DRAINAGE LAYOUT - SHEET 3 OF 3

Rev	Date	Description
C02	20/10/2025	Pond 2 outfall revised for enlarged pond
C01	10/03/2025	Issued for construction
Client: Northvale County Council Designer: Arden Moss Consulting Engineers Kestrel Valley Link Road Drainage Layout Sheet 3 of 3 - Ch 2+800 to 4+200 Drawing number: KVL-ADM-300-DR-D-0302 Revision: C02 Status: FC - For construction Scale: 1:500 @ A1 Date: 20 October 2025 Drawn: SW Checked: DO Approved: PN

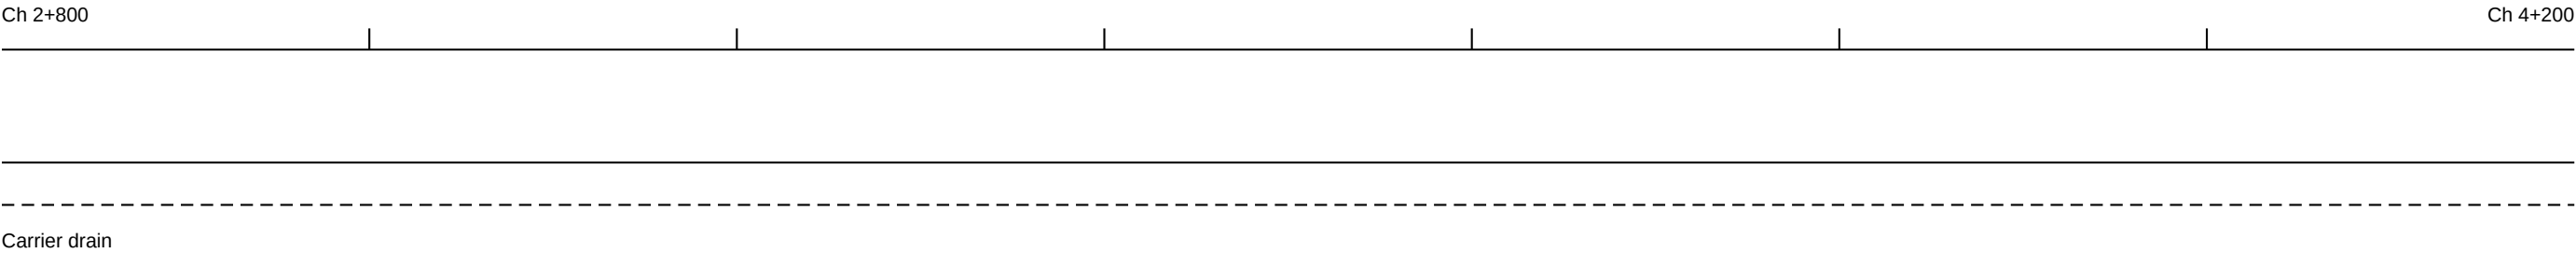
- NOTES**
- 1. Outfall to the enlarged Pond 2 East moved 8 m north at chainage 3+650.
 - 2. Carrier drains 375 mm to 600 mm diameter, unchanged.
